Approved AsNoted
 BY: R. Young
 DATE: 03/07/19
 RESUBMIT: No
 RECEIVED: March 5, 2019
 CKD BY: G. Laroche/G. Dargan/K. Moulton
**STATE OF VERMONT
 AGENCY OF TRANSPORTATION**

UNITED CONCRETE PRODUCTS, Inc. 173 CHURCH STREET YALESVILLE, CT 06492 TEL: (203)-269-3119 FAX: (203)-265-4941	PRECAST CONCRETE THREE SIDED BRIDGE LAYOUT		PROJECT #34491	
	CUSTOMER	BUR CONSTRUCTION, LLC	SCALE	NONE
	JOB	BRIDGE 0138(12) IMPROVEMENTS	DATE	11/09/18
	LOCATION	POULTNEY, VT	DRW	DH
	REVISED	3-08-2019 DH	CHK	JLT

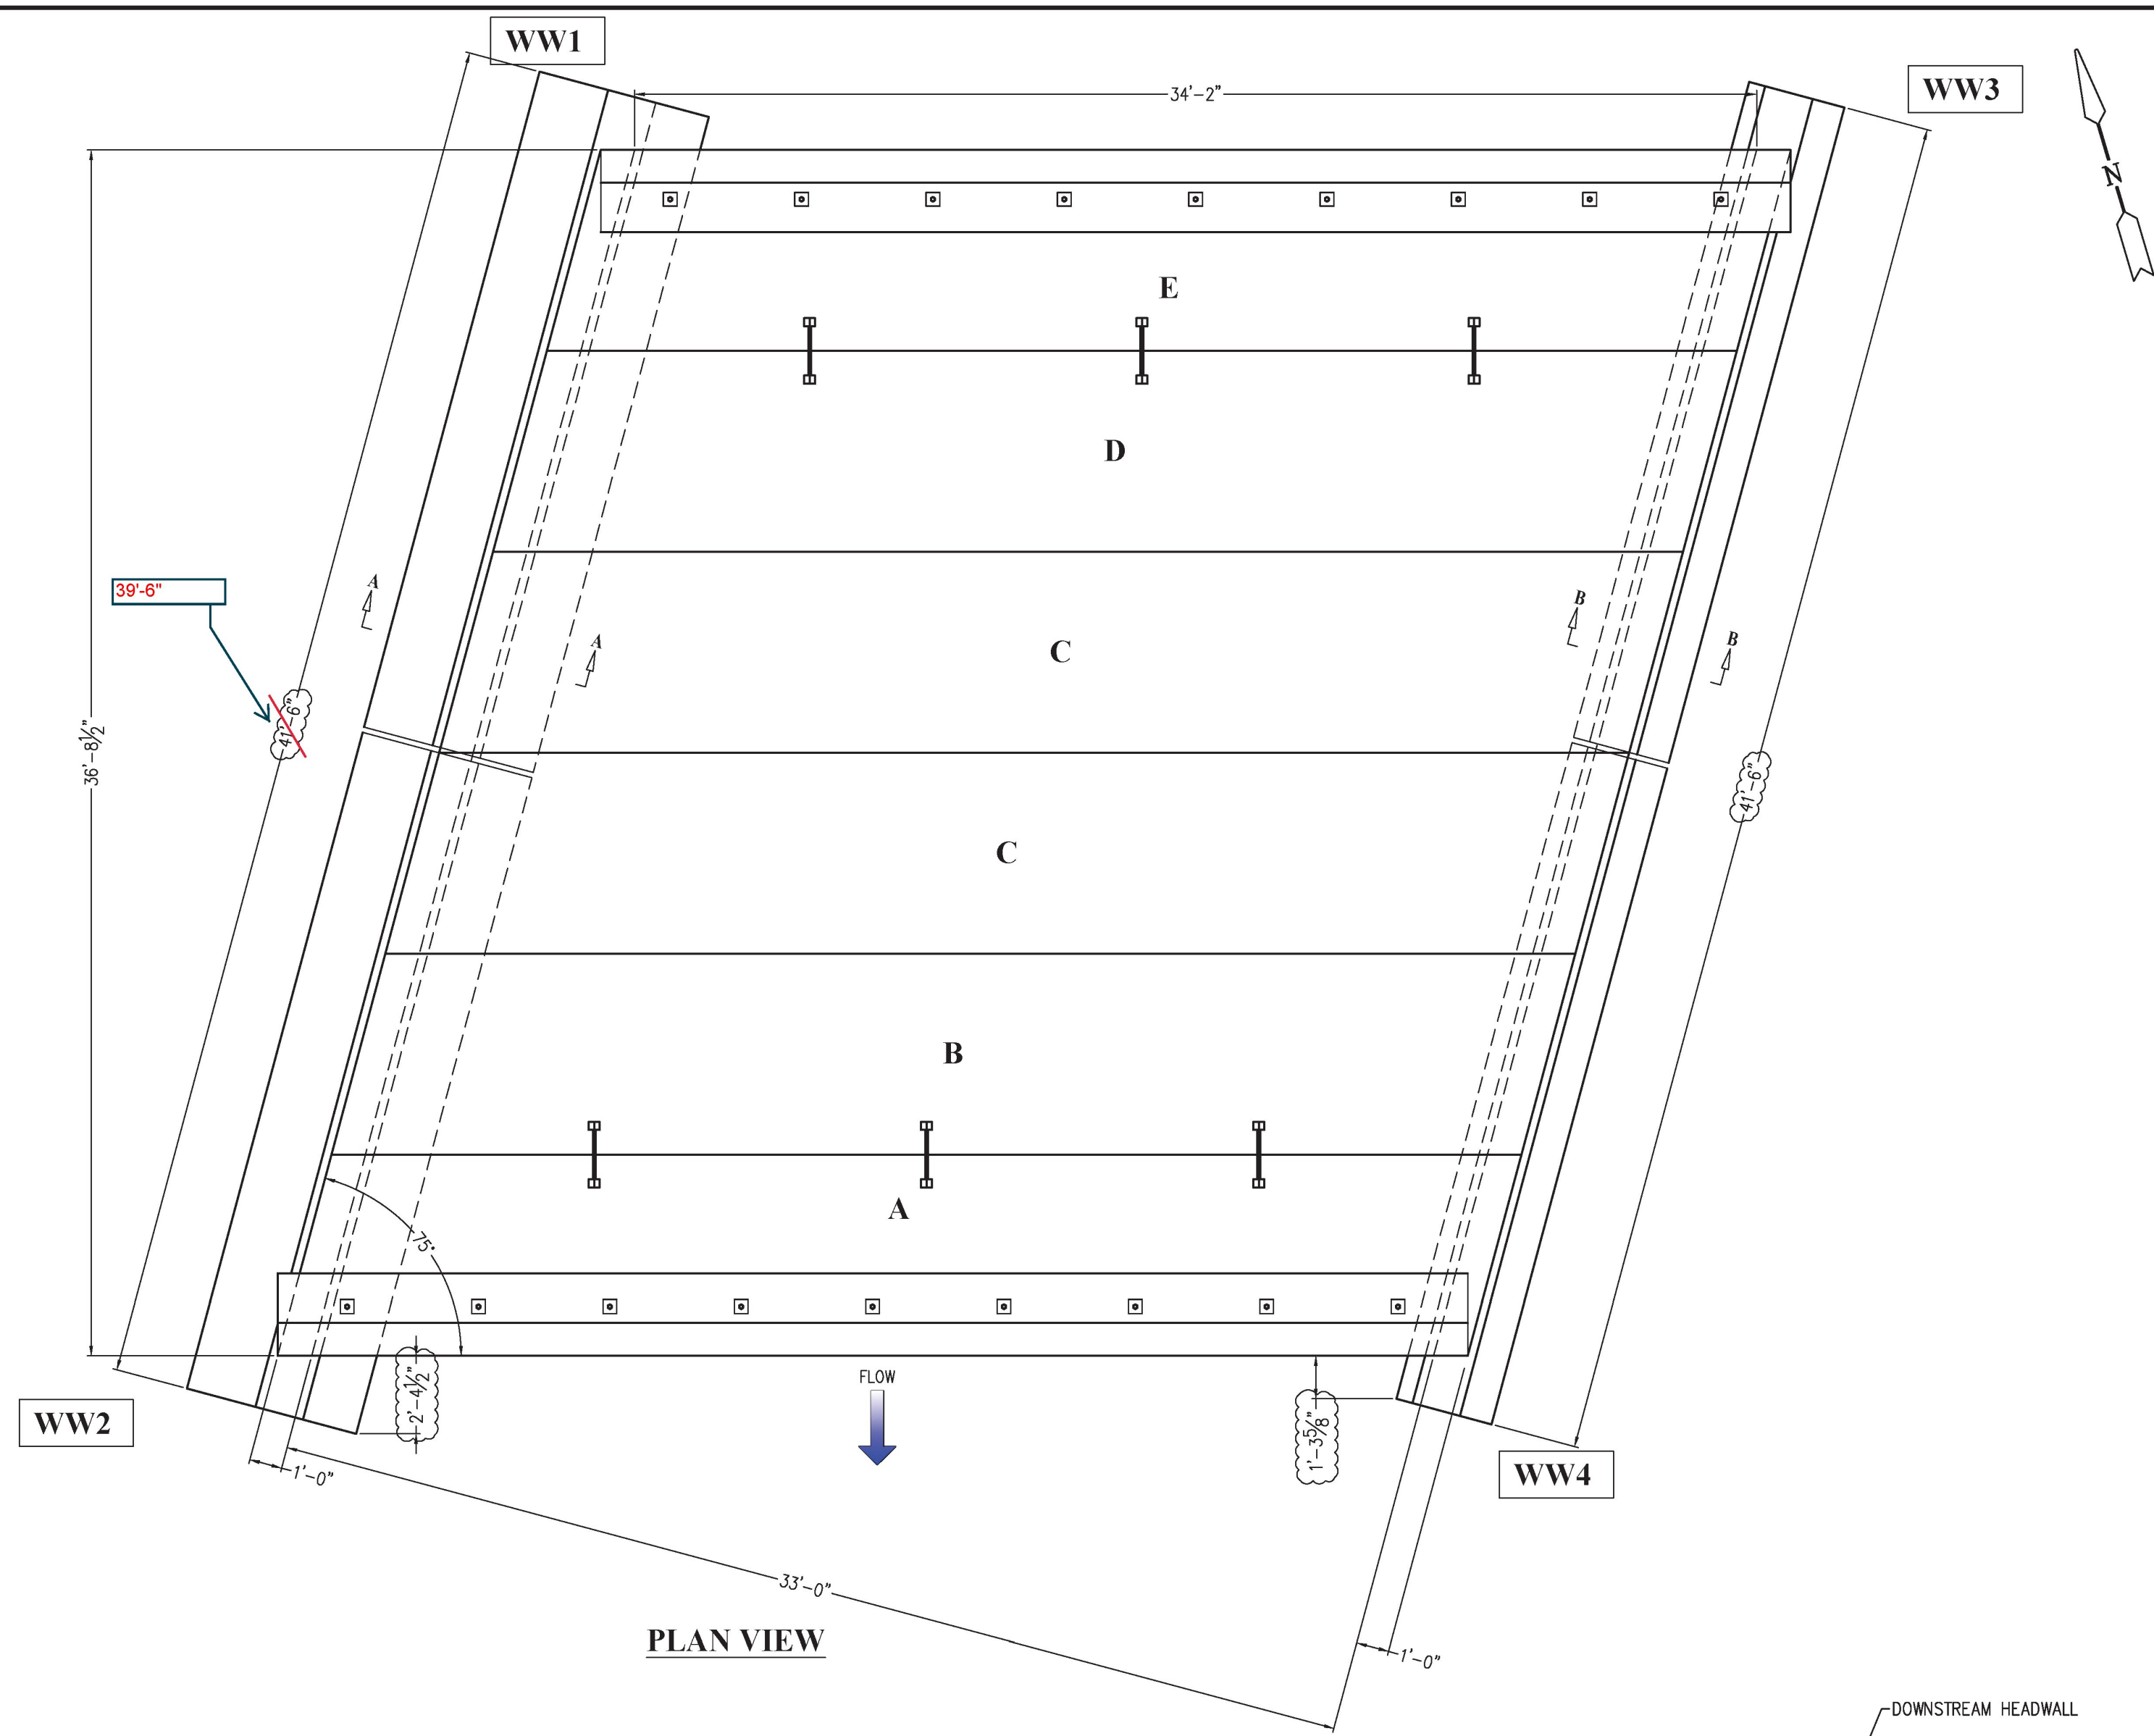
Summing up comments:
 - Curing plant stated on shop drawings
 - Add note: "Concrete clear cover shall be 3" unless otherwise noted."
 - Add note: "All exposed concrete edges shall have a 3/4" chamfer."
 - Retaining wall fabricator removed batter from wall. Abutments may be reduced in size back to plan dimensions (39' - 6").
 - QC Plan: The test methods that are used by the plant for the Certifications or qualifications for the QC workers was not present. QSM did not have a list of personnel that are certified or qualified that do the QC work.

LRFR LOAD RATING FACTORS						
LOADING LEVELS	TRUCK					
	H-10	H-15	SB	6 AXLE	SA STR	SA BEH
TONNAGE	29	36	36	66	30	34.5
INVENTORY	1.87	1.10				
POSTING						
OPERATING	2.65	1.43	2.47	1.24	1.73	2.27
COMMENTS:	TABLE TO BE COMPLETED BY CONTRACTOR'S DESIGNER.
